## TECHNICAL MEMORANDUM

To: Jonathan Rogers  
Cc: Leila Batties  
From: Robert B. Schiesel, P.E.  
Daniel VanPelt, P.E., PTOE  
Date: September 16, 2019  
Subject: Sursum Corda Phase 1 Stage 2 PUD (ZC Case No. 15-20C)  
Response to DDOT CTR Comments

# **ATTACHMENT A: MOVE-IN DISTANCE COMPARISONS**

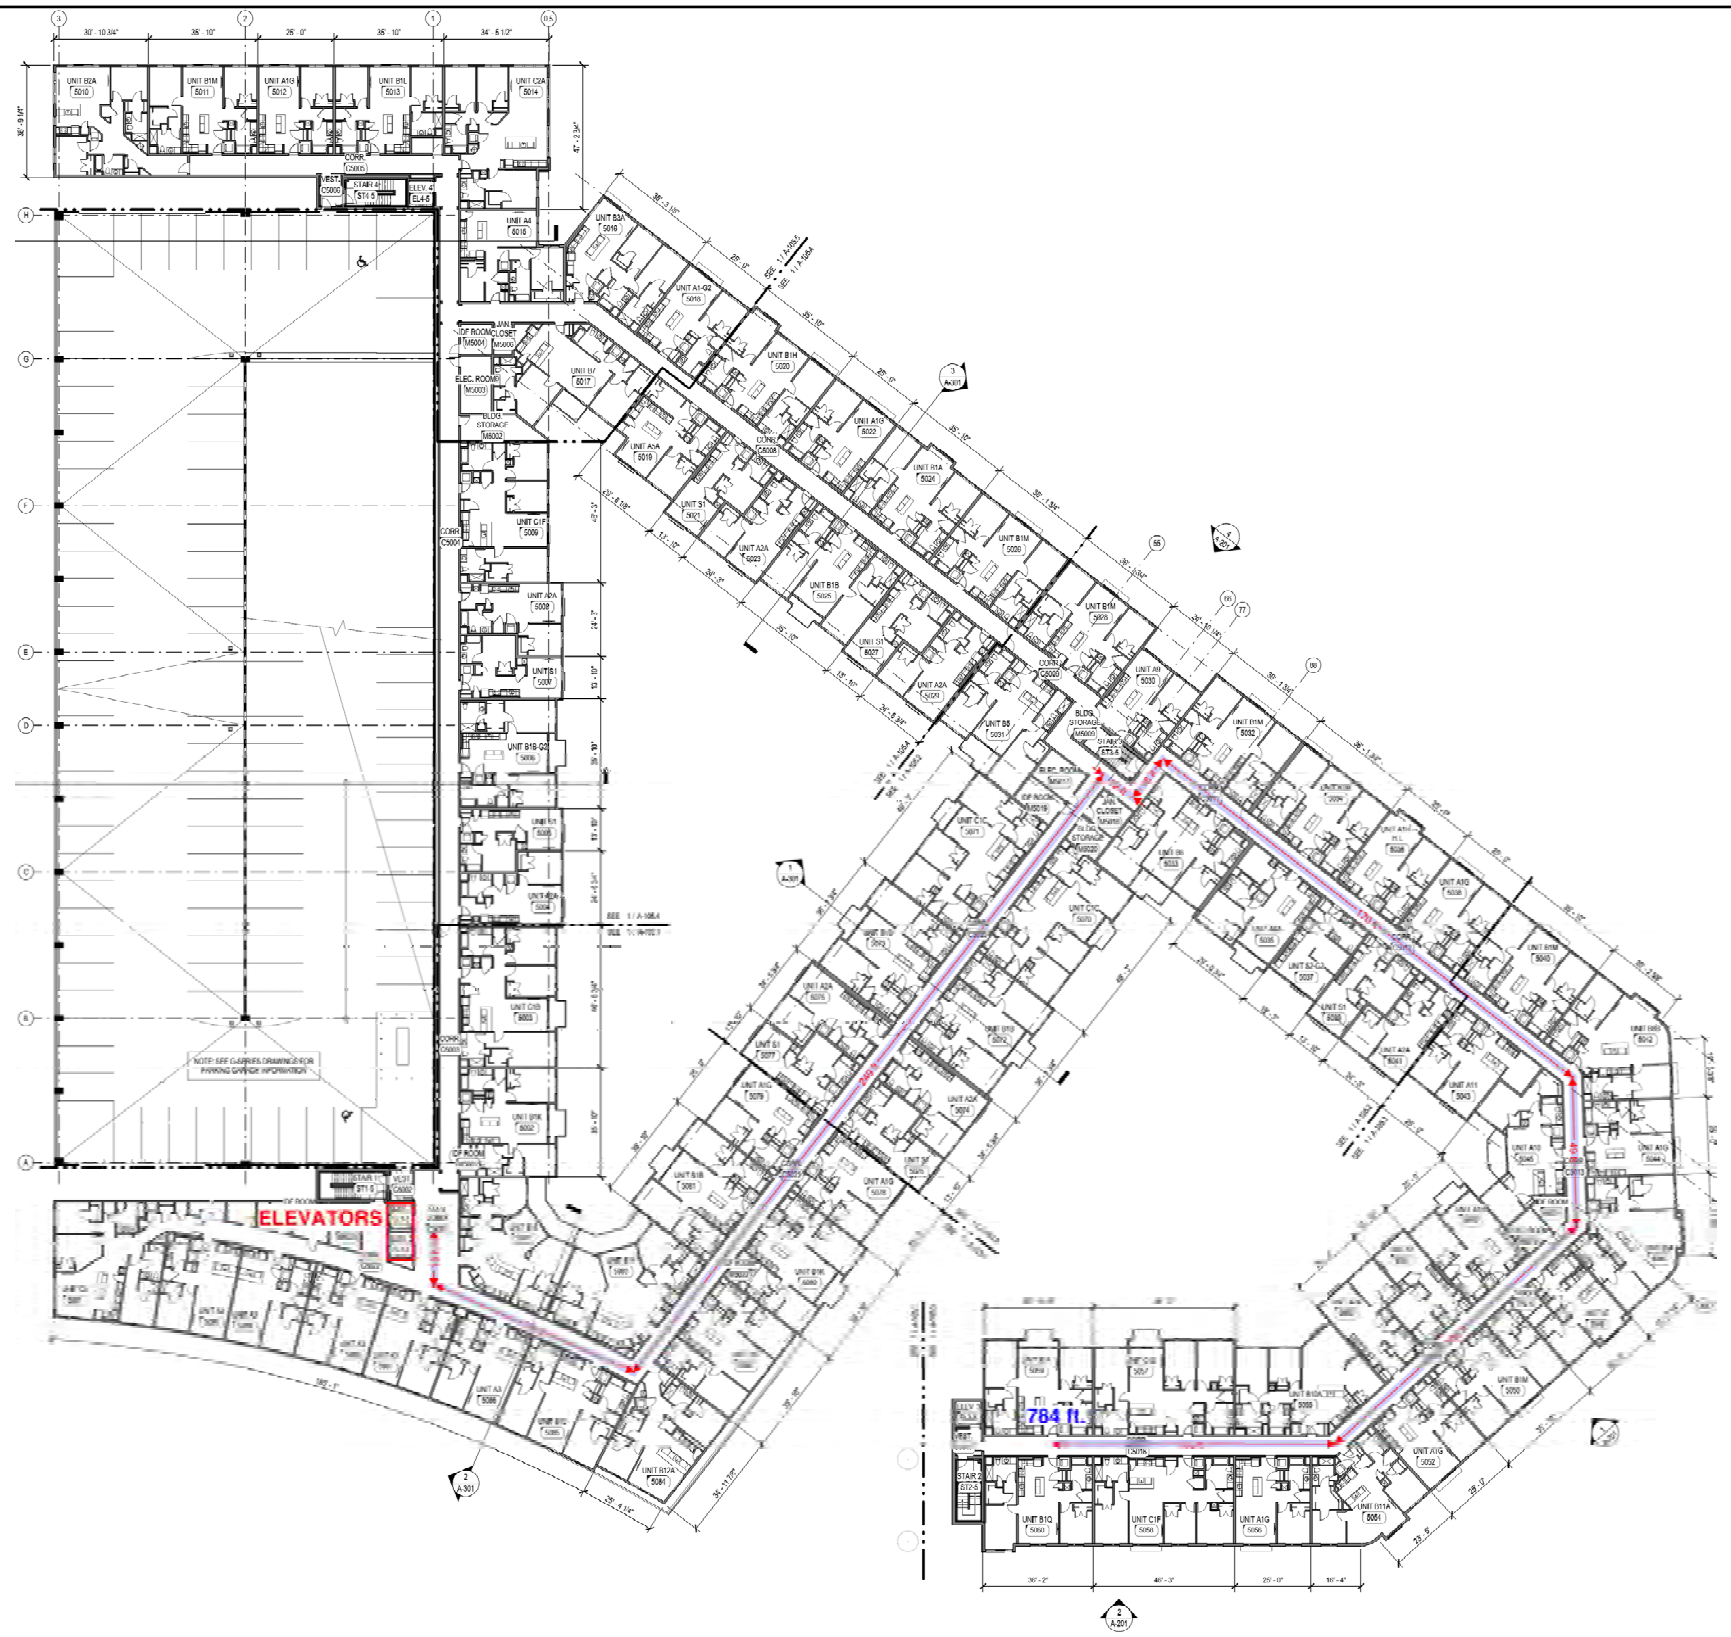
**DDOT expressed concern about the distance residential move-in/move-outs would have between the loading dock and elevators in the parking garage. DDOT requested that the Applicant provide examples of how the proposed move in/move out arrangement has been successful on other projects.**

*Applicant Response: The Applicant has other residential buildings that have longer move-in distances. Toll Brothers Apartment Living currently operates the Kenrick building in Needham, Massachusetts, and the Kensington building in East Brunswick, New Jersey. Both buildings have longer move-in distances than the proposed Phase 1 building. As shown in Attachment A, The Kenrick's longest move-in distance is approximately 900 feet and the Kensington's move-in distance is 875 feet. The longest move-in distance for the Phase 1 building is approximately 675 feet. Property managers of both the Kendrick and Kensington buildings have not received complaints from residents about the situation or have any reported issues with the move-in distances. Neither the Kendrick nor Kensington buildings has an alternative loading area, for example an adjacent curbside loading/unloading zone.*

*The Applicant also agrees to paint a striped path from the loading dock to the elevators on the SW building to indicate path of travel (also shown on Attachment A).*
